SUNDRY NOTICES AND REPORTS ON WELLS
Do not use this form for proposals to drill or to re-enter an abandoned well. Use form 3160-3 (APD) for such proposals.

1. Type of Well <input checked="" type="checkbox"/> Oil Well <input type="checkbox"/> Gas Well <input type="checkbox"/> Other		8. Well Name and No. MCINTYRE B 7
2. Name of Operator COG OPERATING LLC Contact: KANICIA CASTILLO E-Mail: kcastillo@concho.com		9. API Well No. 30-015-31561
3a. Address 600 W ILLINOIS AVE MIDLAND, TX 79701	3b. Phone No. (include area code) Ph: 432-685-4332	10. Field and Pool or Exploratory Area LOCO HILLS; GLORIETA YESO <i>Grayburg Jackson SR O.G.S.A.</i>
4. Location of Well (Footage, Sec., T., R., M., or Survey Description) Sec 20 T17S R30E Mer NMP 330FSL 330FWL		11. County or Parish, State EDDY COUNTY, NM

COG Operating LLC, respectfully requests to recomplete to the San Andres as follows:
MCINTYRE B #7

**Mcintyre B 7
30-015-31561
COG Operating LLC
April 12, 2018
Conditions of Approval**

Proposed

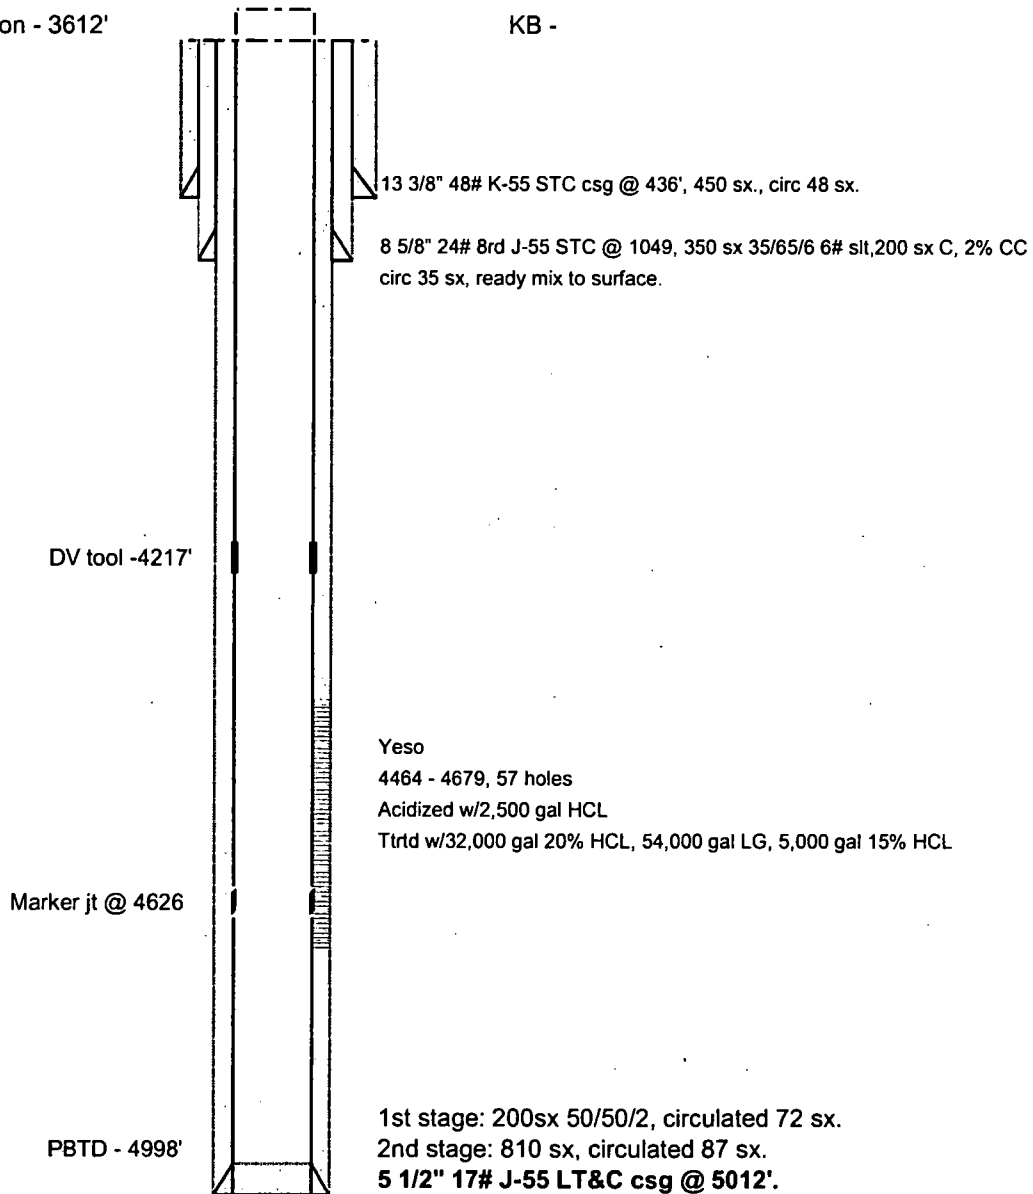
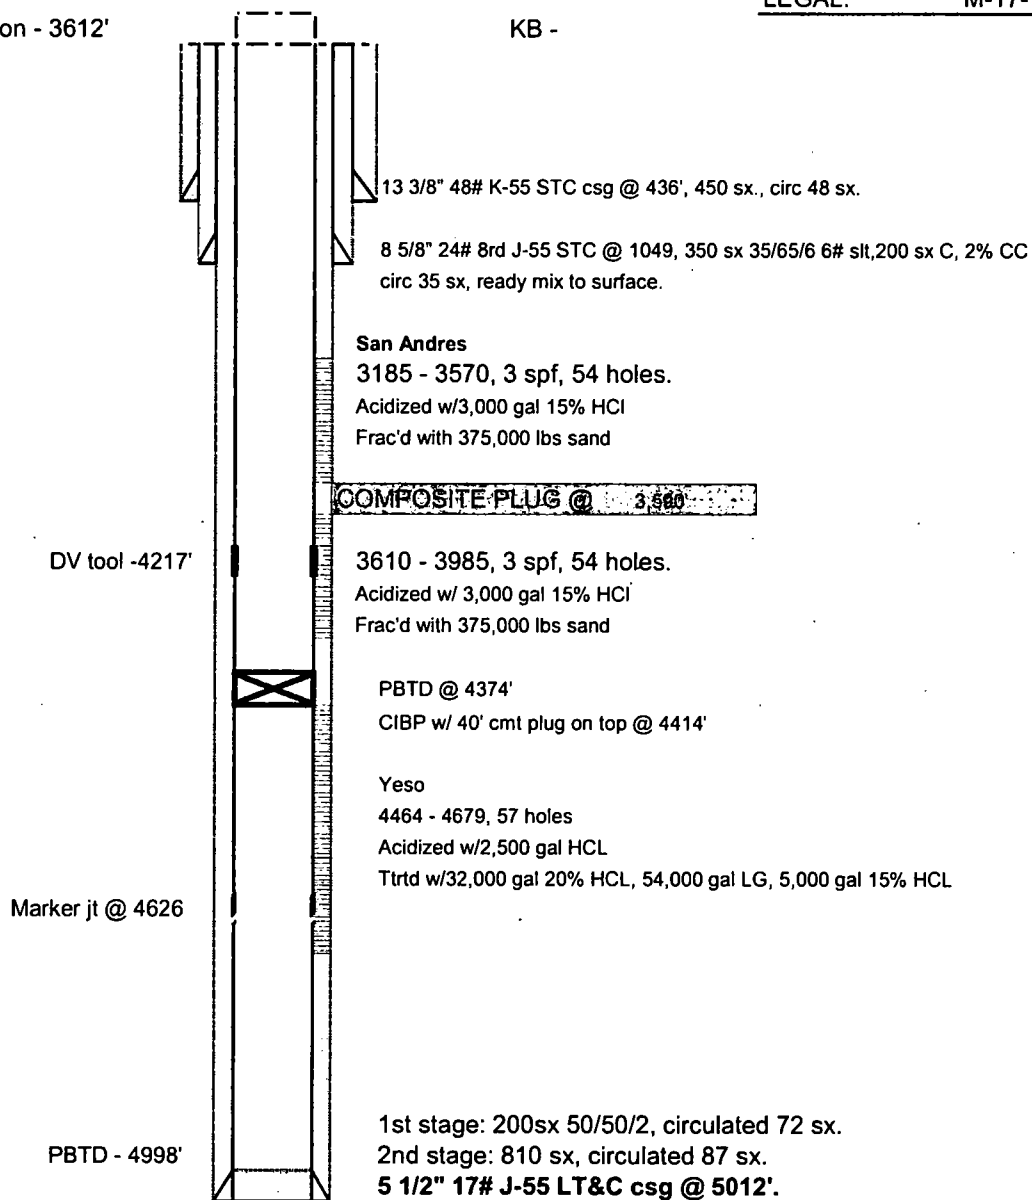
- 1. Operator shall place a CIBP at 4,414' and place 40' Class C Cement on top of the CIBP. WOC and TAG.**

Note: At a later date, operator will need to add 110' of cement to the CIBP to properly seal the Glorietta Formation.

- 2. Must conduct a casing integrity test before perforating and fracturing. Submit results to BLM. The CIT is to be performed on the production casing to max treating pressure. Notify BLM if test fails.**
